Independent Hearing and Assessment Panel | 24 July 2019

IHAP No.	Item 2
DA No.	DA-2015/952/B
Proposal	Residential – alterations and additions Modification B - amend dwelling addition design to include increased building height greater than 9 metres
Property	2C Pass Avenue, Thirroul NSW 2515 Lot 48 DP 10972
Applicant	PDC Planners
Responsible Team	Development Assessment and Certification – Building and Certification Team (CB)

ASSESSMENT REPORT AND RECOMMENDATION

FIGURE 1: Overlay survey plan showing location of highest part of the dwelling at 2C Pass Avenue, Thirroul

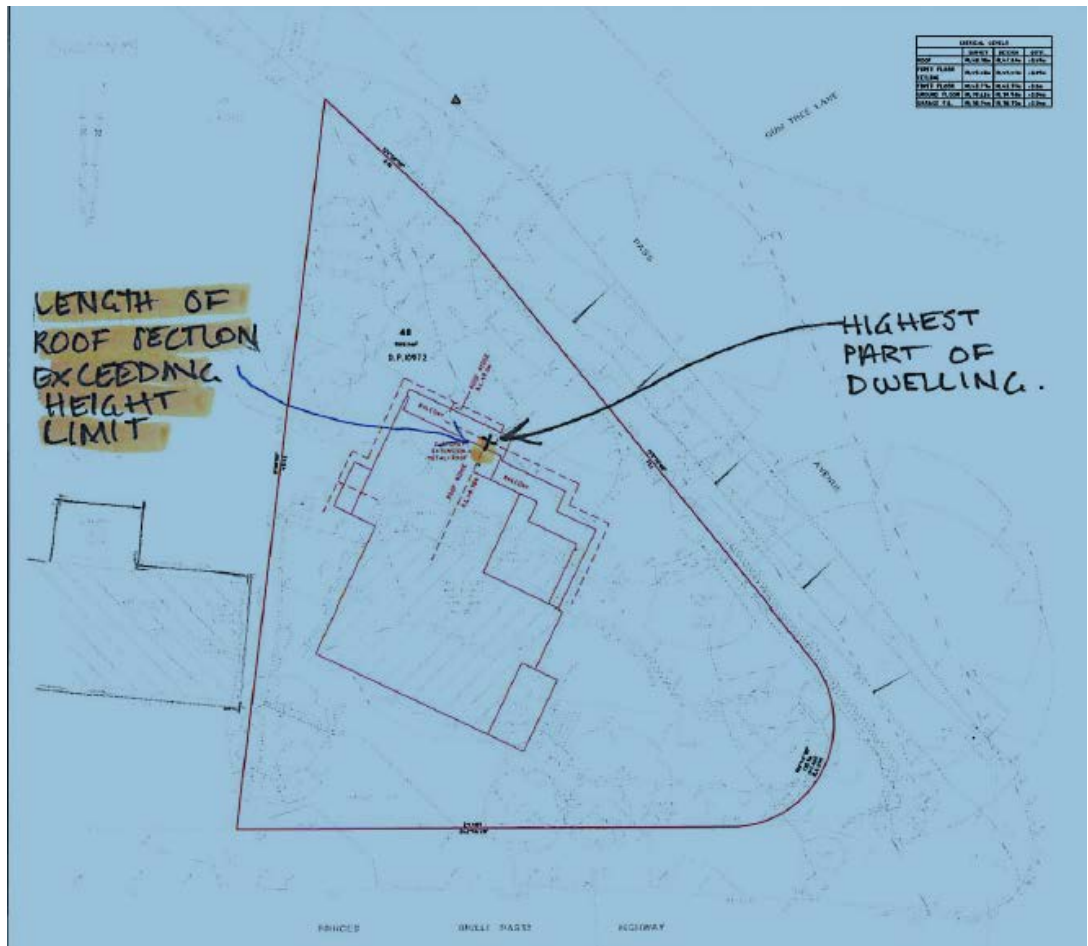
The highest point of the dwelling is at the end of the large gable ridge as seen from the north east elevation (See Figures 1 & 3). The ridge height of the larger gable roof is revised at RL48.38 metres. Existing ground level directly below this point was calculated by measuring the distance between this point and the two nearest pre-development contours (RL38 m & RL39m respectively) from the revised survey plan, and then obtaining a percentage value to determine that the existing ground level was 38.98m.

Modified Building Height = $RL48.38 - RL38.98 = 9.4$ metres. The 9.4 metre building height represents a 4.44% departure from the development standard.

The distance between the RL39m & RL40m contour along the roof ridgeline is 3.465m. 38% percent of this figure is 1.317m. This figure is added to 0.153m (distance of the roof ridge from 39m contour to the end of the roof) to obtain a distance of 1.47 metres. Therefore, a 1.47 metre section of the gable roof exceeds 9 metres in height.

SITE PLAN

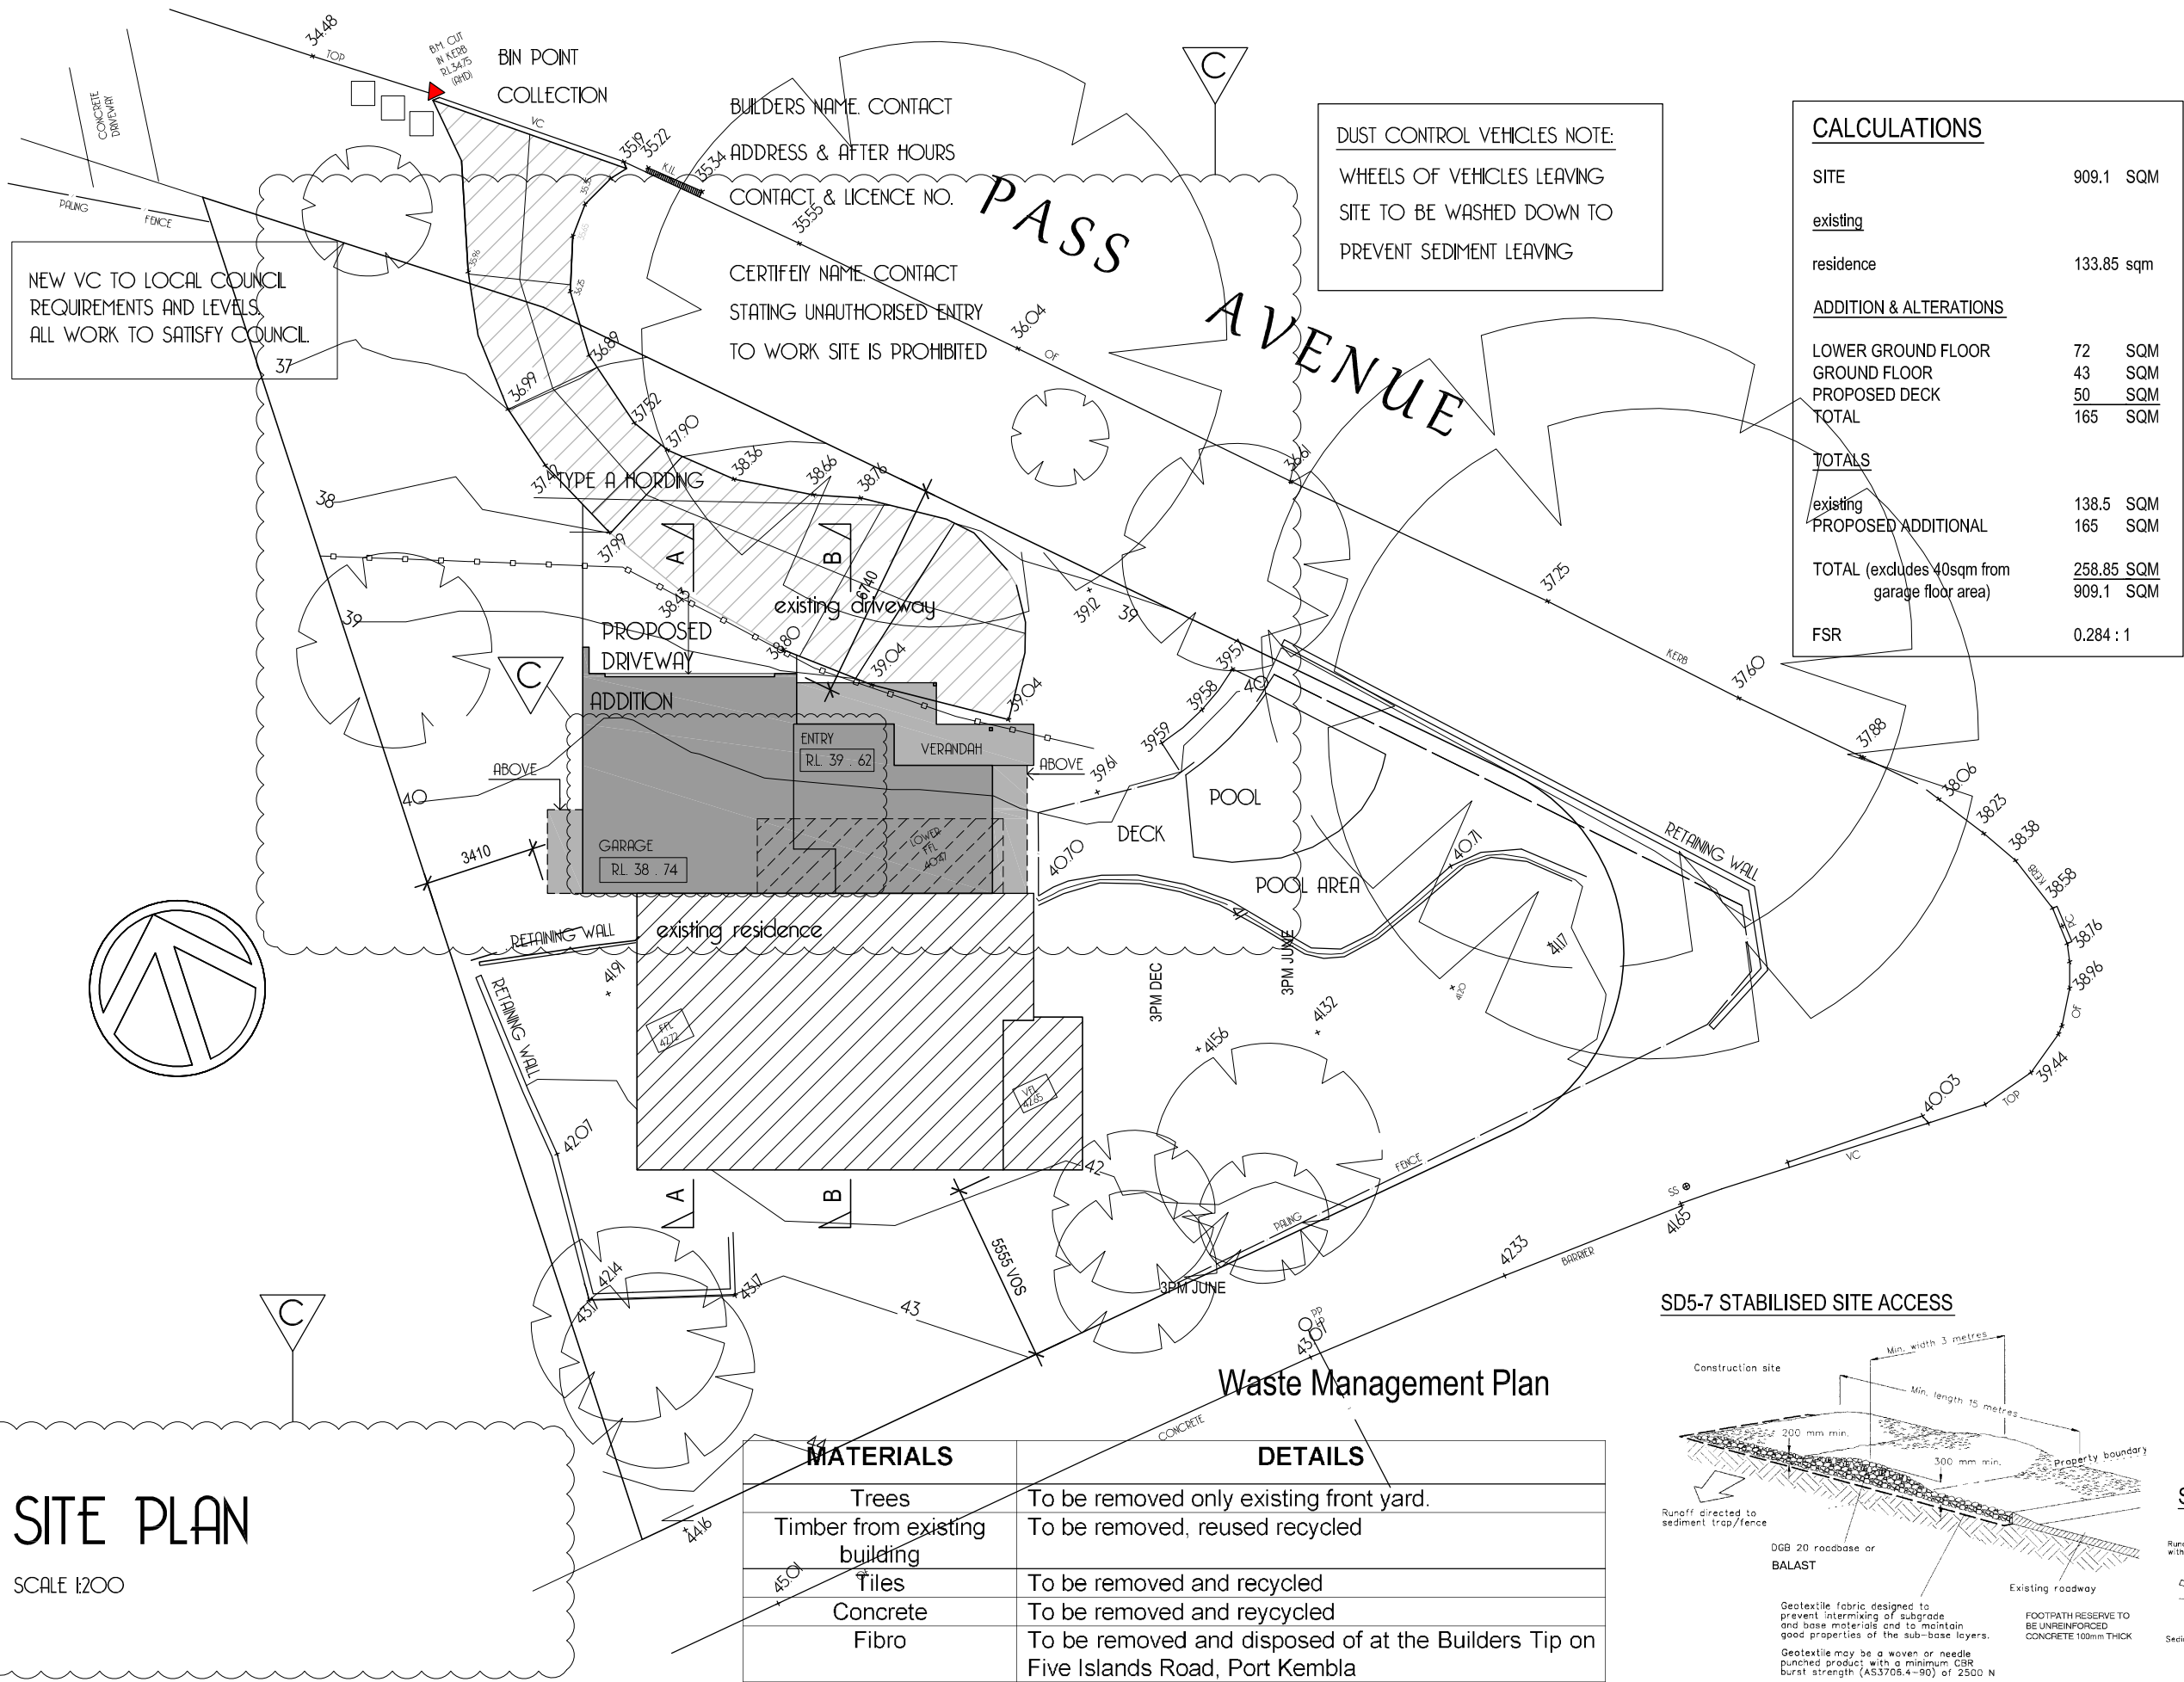
- Reduction in western side setback of 1.06 metres with first floor ensuite shown on the Site Plan [From 4.47m to 3.41m]
- Increase in width of first floor northeast dwelling addition from 14.67m to 14.753m

Above: North east elevation showing the constructed dwelling. The approved roof pitch and height it indicated by the red lines.

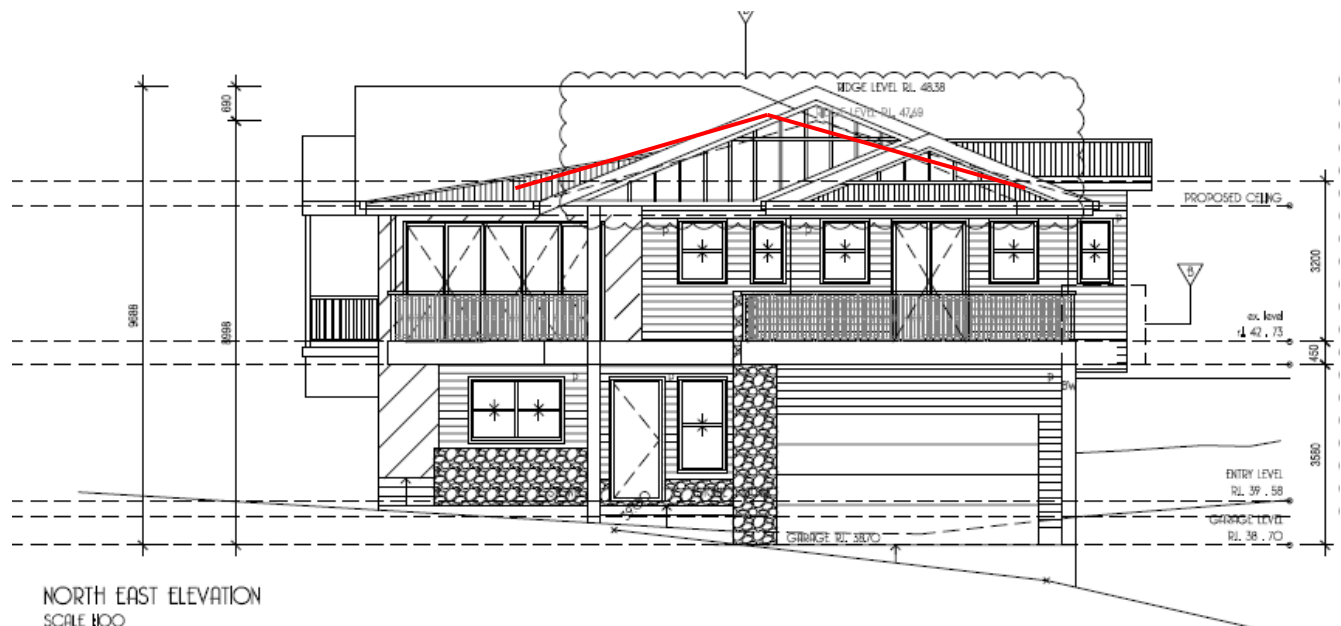
The dwelling was approved with a maximum overall height of 8.998m AHD above the FFL of the garage under DA-2015/952. Post construction a survey was carried out which identified non-compliance with design floor levels and ridge heights as shown below (and on survey certificate).

CRITICAL LEVELS			
	SURVEY	DESIGN	DIFF.
GROUND FLOOR	RL 39.62m	RL 39.58m	+0.04m
GARAGE F.L.	RL 38.74m	RL 38.70m	+0.04m
ROOF	RL 48.38m	RL 47.69m	+0.69m

The floor level of the garage had been constructed 40mm higher than designed. The roof pitch had also been constructed an additional 650mm higher resulting in an overall exceedance of the approved height of 0.69m. It appears that this has occurred due to an increase to the roof pitch as the floor and ceiling heights are consistent with the design (both out by 40mm). The updated design plans show the relationship between the approved design and the constructed design (north-east elevation reproduced below). The increased roof pitch and resultant height exceedance is evident.
